ARCHITECT'S ADDENDUM

Addendum Number: 003

RE: EASD #131 East Aurora High School
2027 Mechanical Improvements

Subject: Addendum No. 003 to the Construction Documents for the EASD #131 East Aurora High School 2027 Mechanical Improvements Project.

D-E0.2

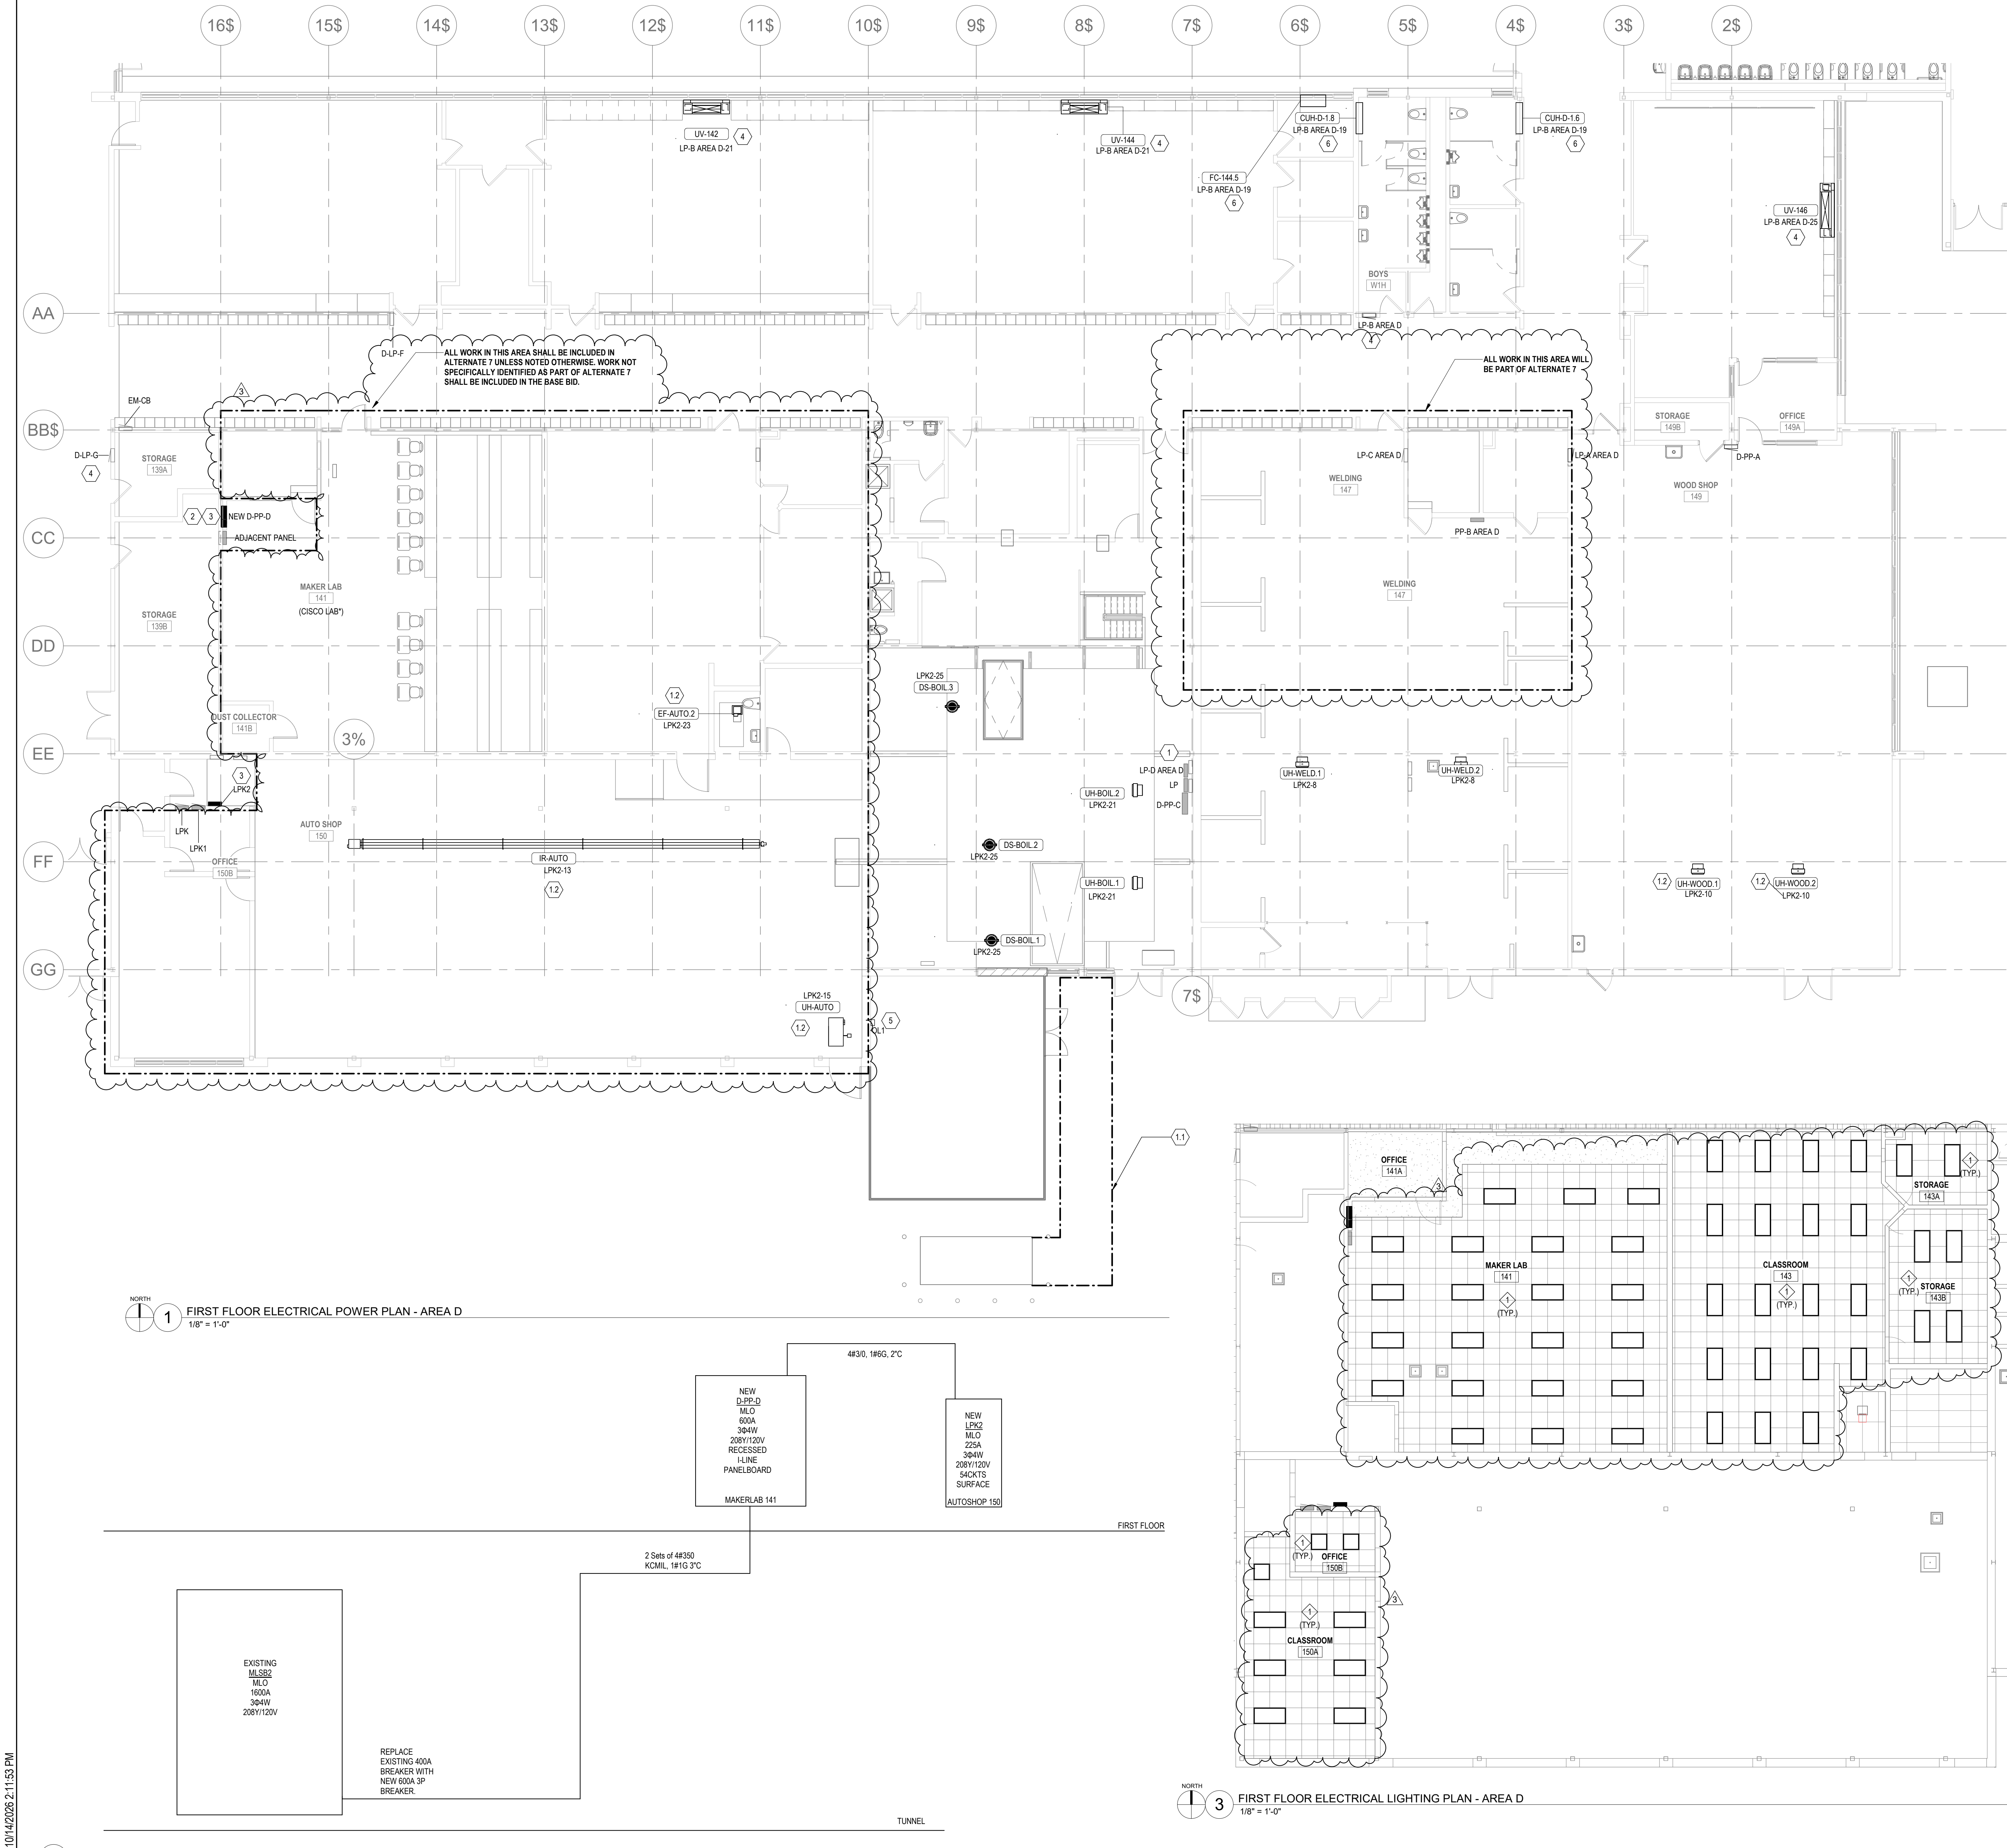
2. D-E0.2 – ROOF ELECTRICAL DEMOLITION PLAN

- **REVISED** drawing notes to indicate that all work shown on this sheet is included in Alternate #07.

1 ROOF ELECTRICAL POWER PLAN - AREA D
1/8" = 1'-0"

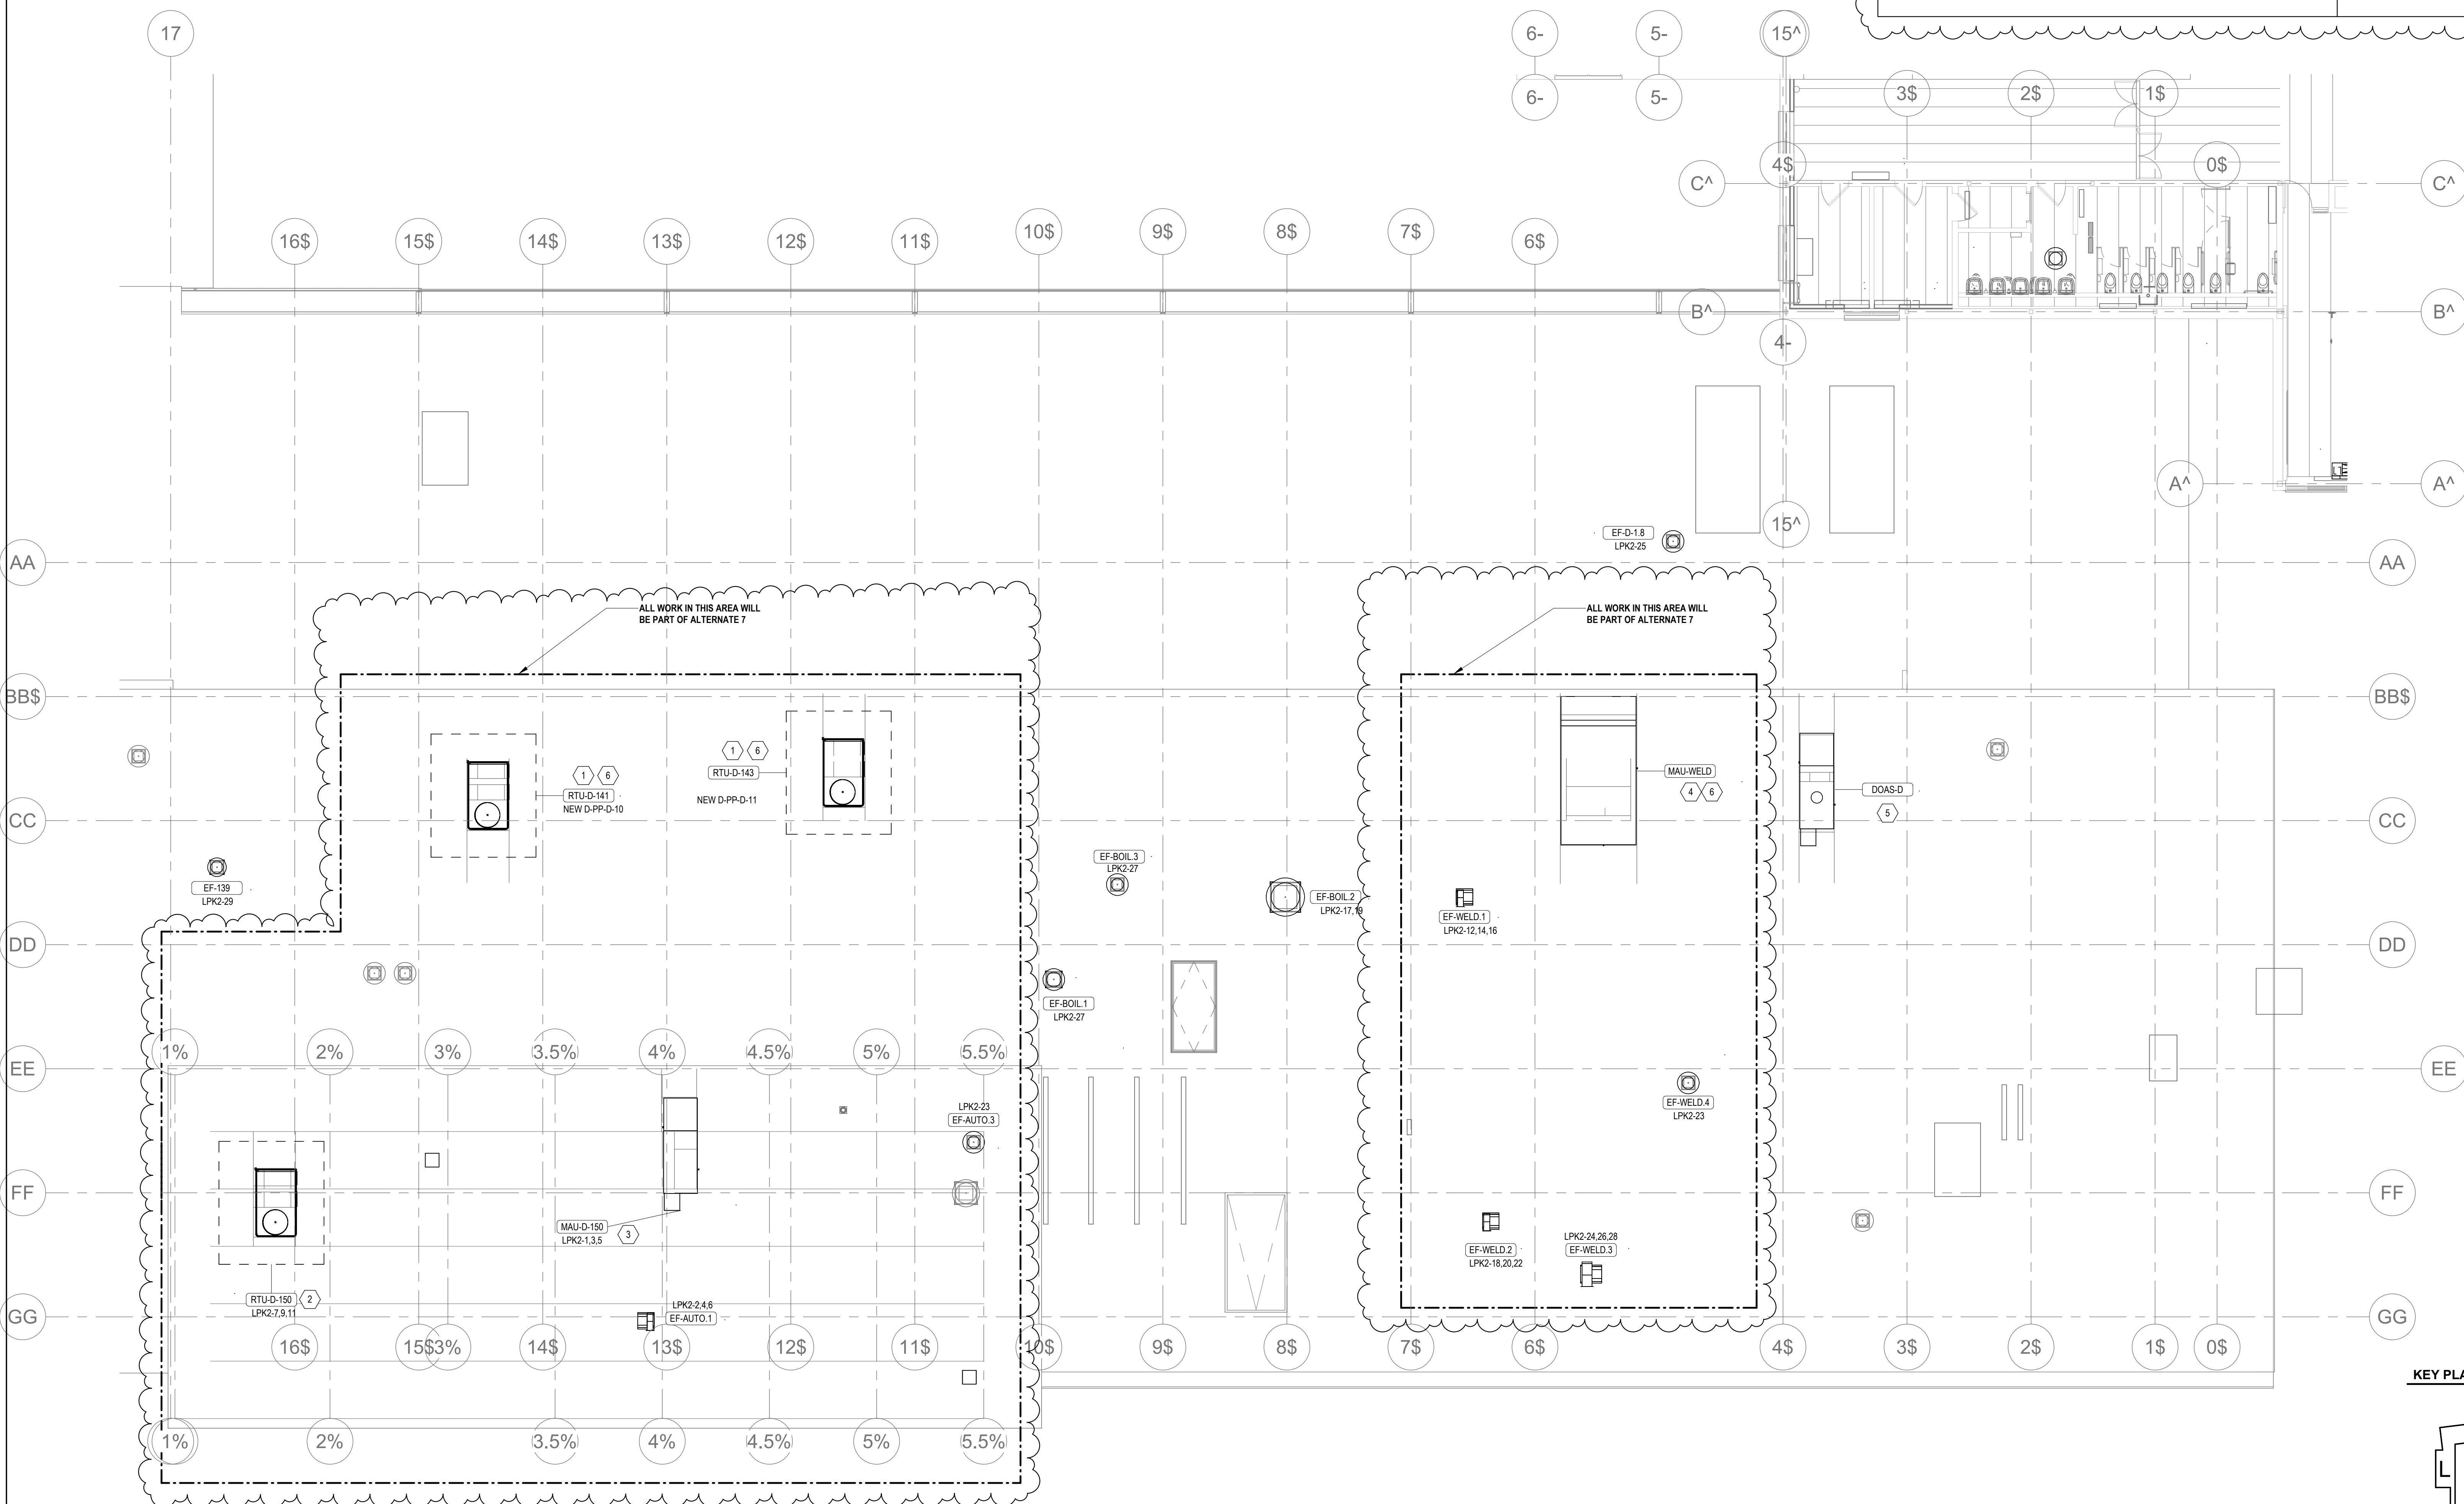
4. D-E2.3 – ROOF ELECTRICAL POWER PLAN

- **ADDED** equipment connection schedule for alternate work.
